**Subject: Amendment 3, M-77-211 – Adequacy Review Response  
Continental Materials Corporation, Transit Mix Aggregates, Castle Concrete  
Pikeview Quarry**

Transit Mix Aggregates is forwarding five copies of the revised Permit Amendment 3 permit application for Pikeview Quarry in response to October 15, 2012 Adequacy Review Comment letter.

## **EXHIBIT B INDEX MAP**

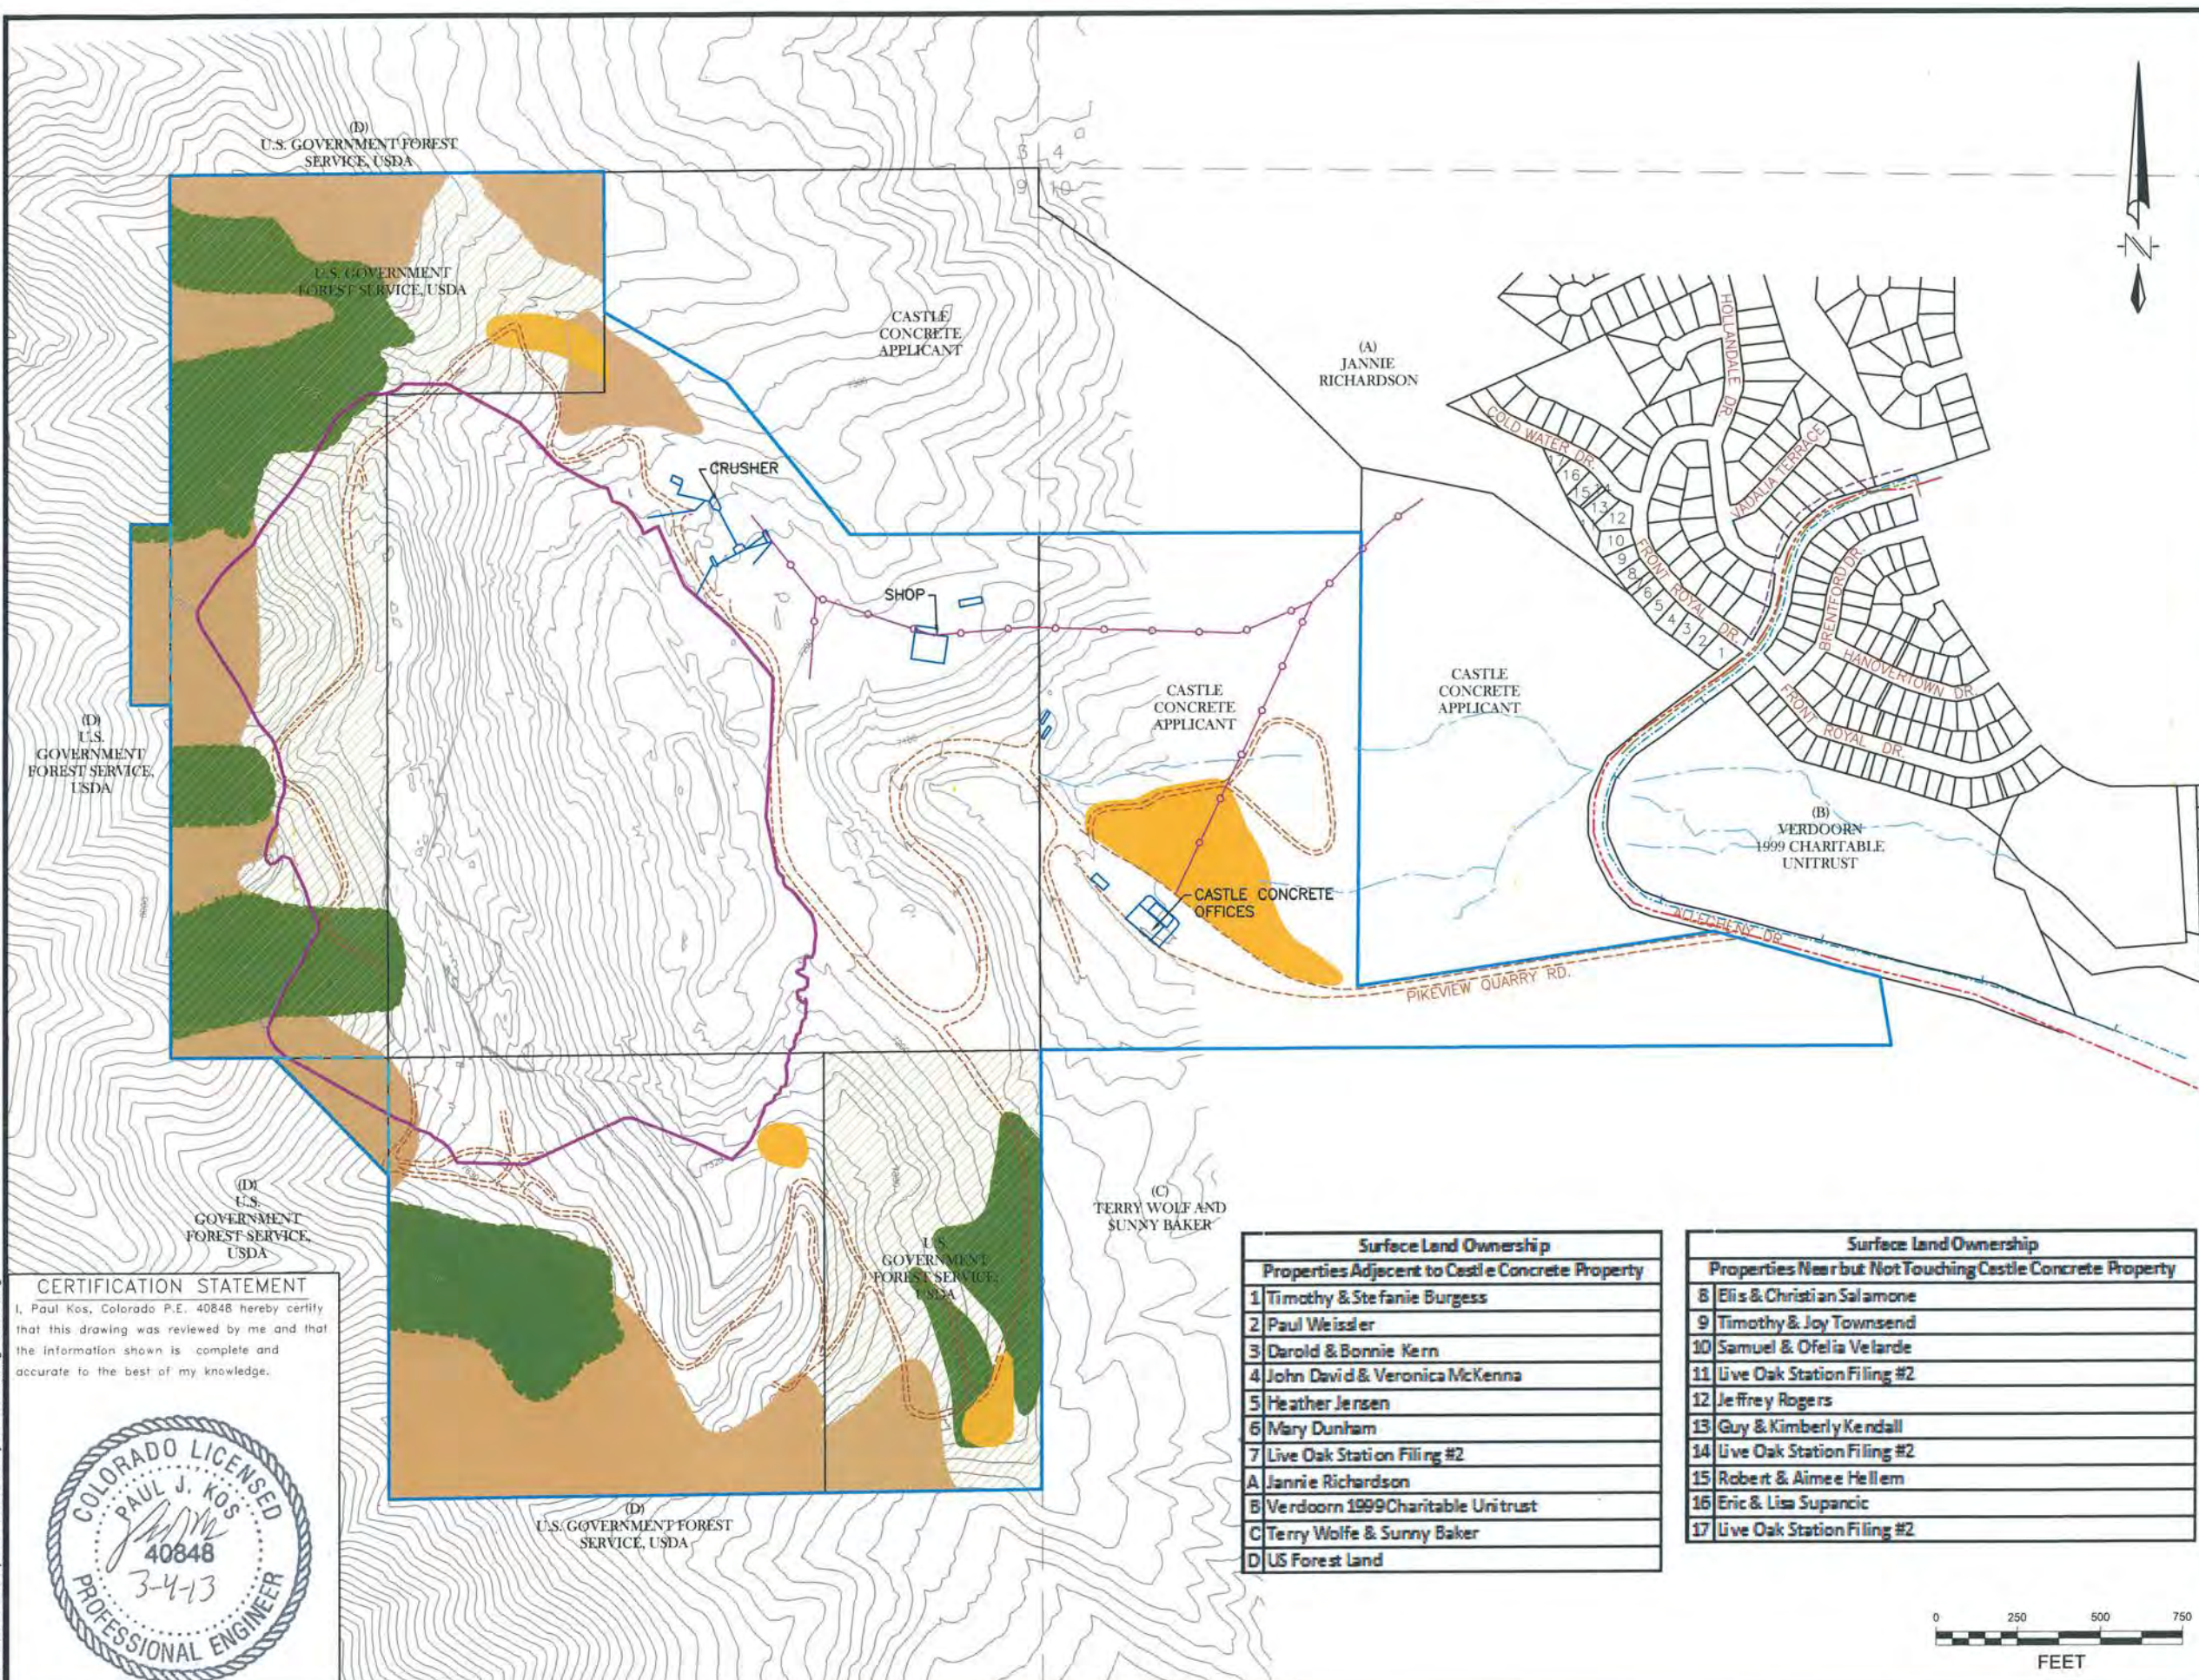
The Index map refers to Amendment #4; it should be labeled Amendment #3. In addition, the total added area equals 4.5 acres when it should be 4.46 acres. Please refer to comment 1, above. Please provide a new Index map that is properly labeled.

*Exhibit B, the Index Map, includes the change referencing Amendment #3.*

## **EXHIBIT C MINING PLAN MAPS OF AFFECTED LANDS**

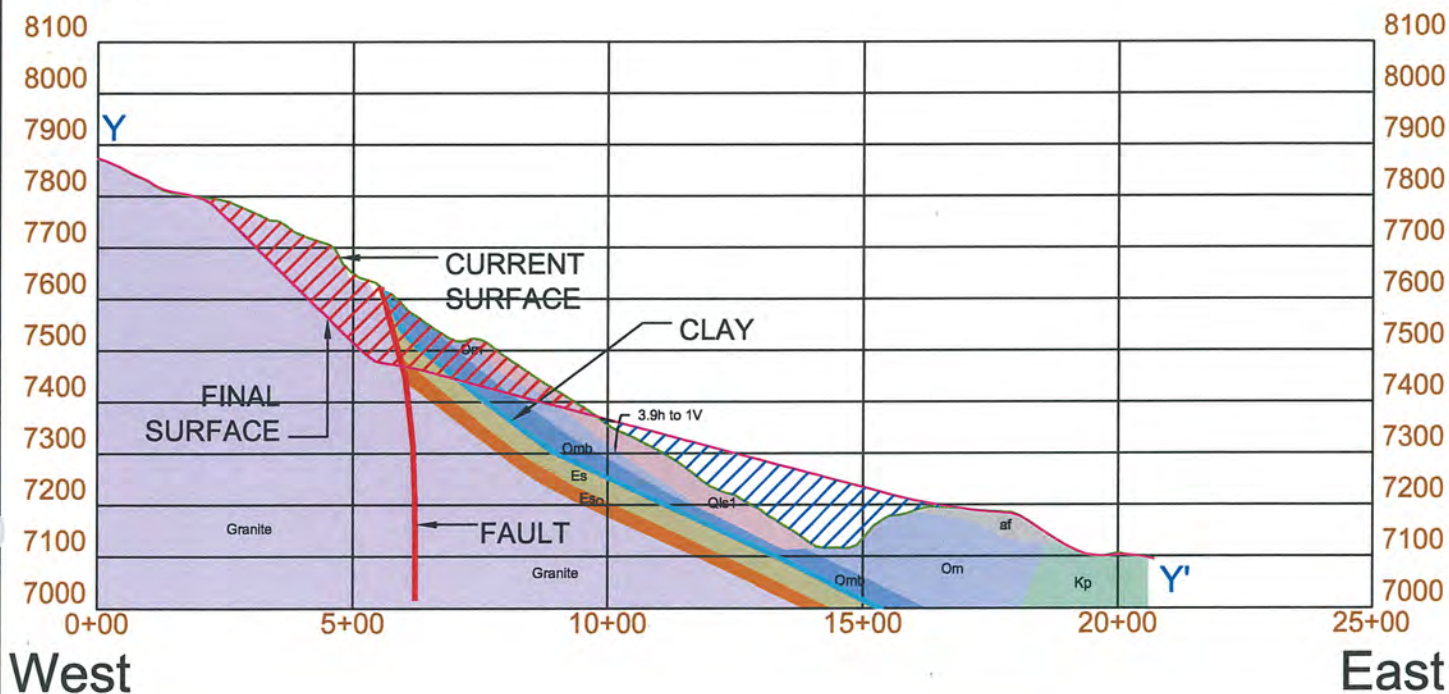
- 4) Please provide location and possible source and quantity of the donated topsoil in the facilities map.

*Donated topsoil and organic materials will be stockpiled in the zones identified on Exhibit C-1. The largest area will be located north from the office in piles that may be 30 feet high. Soil will come from development in the greater Colorado Springs area and from individuals disposing of fill. It is anticipated that 81,514 LCY are needed to provide an average 0.5 foot of plant growth medium. (No changes have been made to the permit.) It is anticipated that 27,917 LCY will be salvaged during the stabilization operations (page D-9).*
